Network Rail Suffolk Level Crossing Reduction Order, 2017

I wish to present my comments raising objection to part of the changes proposed within the draft Transport and Works Act Order for the closure of the Suffolk "Stacpool" crossing, identified as "S08" in the draft Order.

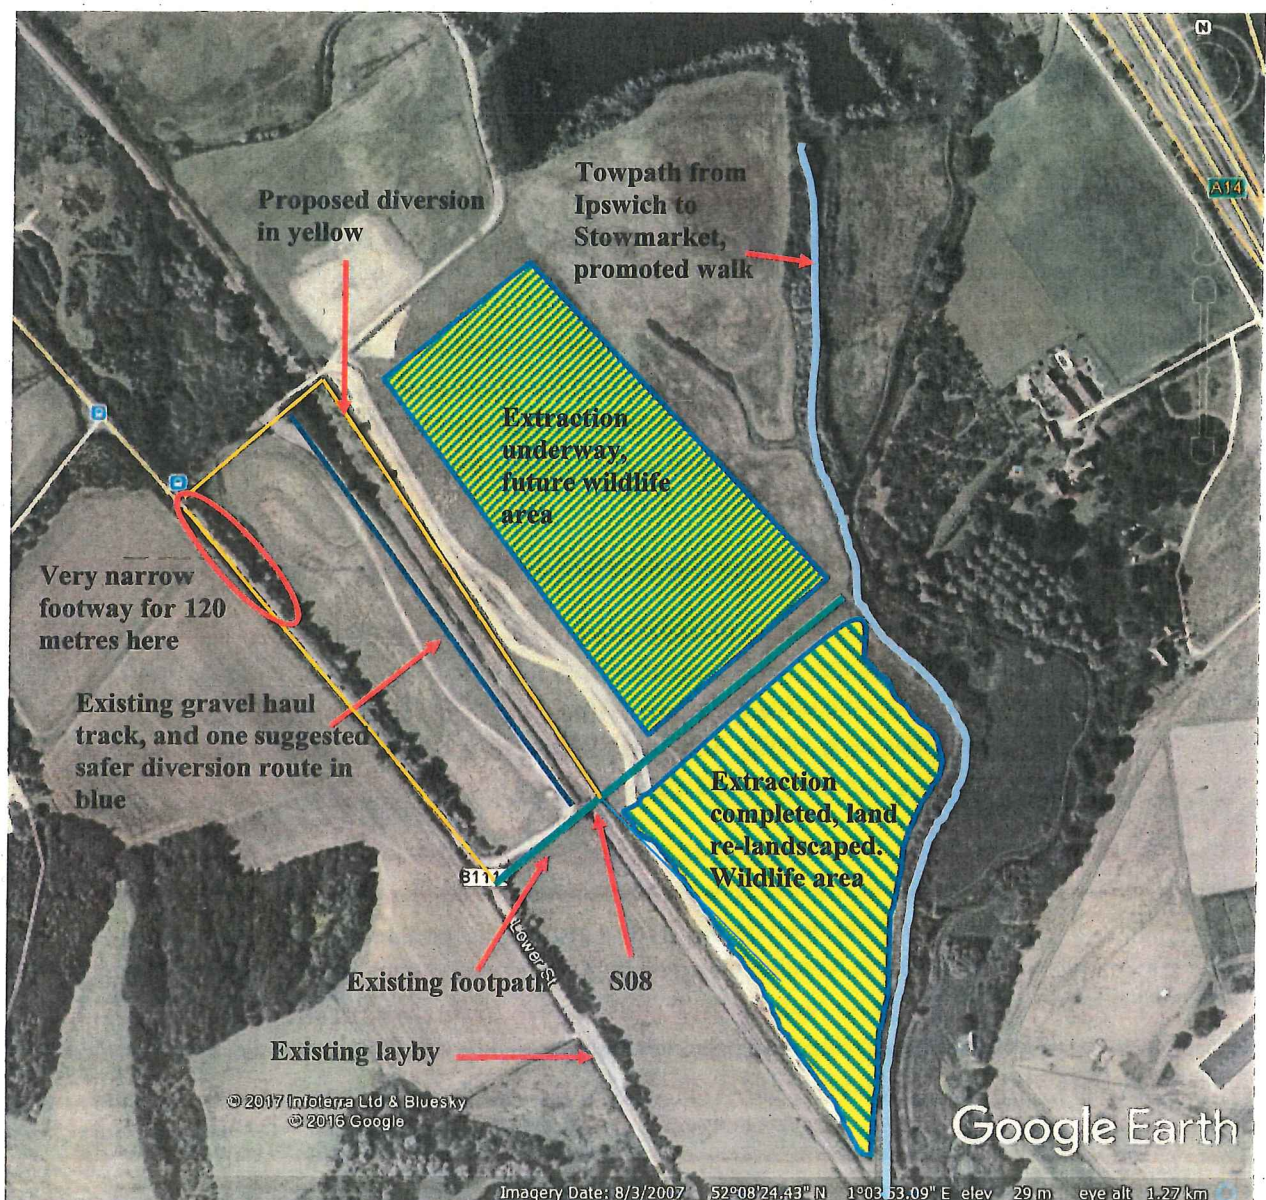
About 120 metres to the South East of the point where the footpath carried by S08 emerges onto the B1113 there is a large layby beside the B1113 separated by a raised island from the main carriageway. There is a footway alongside the B1113 to the east of the carriageway. For most of the length of road in question this footway is just over a metre wide, and is separated from the carriageway by a grassed strip about one metre wide, with a further vegetated strip to the east supporting small trees and the occasional mature oak tree.

As proposed it will be possible to park in the layby and then walk alongside the B1113 heading north west using the B1113 footway to the point where the proposed diversion route joins the B1113. However, the section of approximately 120 metres at the north west end of this footway is, I strongly believe, **very hazardous for pedestrians**. Whereas most of the footway is over a metres wide, and is separated from the carriageway by a grass strip about a metre wide, and has a generally

fairly level, sparsely treed area on the other side, the 120 metre section of B1113 footway at the north west end is only a metre wide, lacks any strip separating it from the carriageway and has a high, steep bank on the other side. To make this worse, this is the exact area where the road narrows considerably, where there is a vision limiting hill and where there is a minor road joining the B1113 all creating traffic hazards.

Provide a wider footway for the first 120 metres, separated from the carriageway, by widening the existing footway.

Provide a new footpath just to the east of the current hedgerow beside the B1113 so pedestrians stay "inside" the field lying to the east of the B1113.

Provide a footpath alongside the railway track. Note that there is already a gravel haul track along this length just as there is on the other side of the tracks. The draft Order includes providing access to this track for construction works.
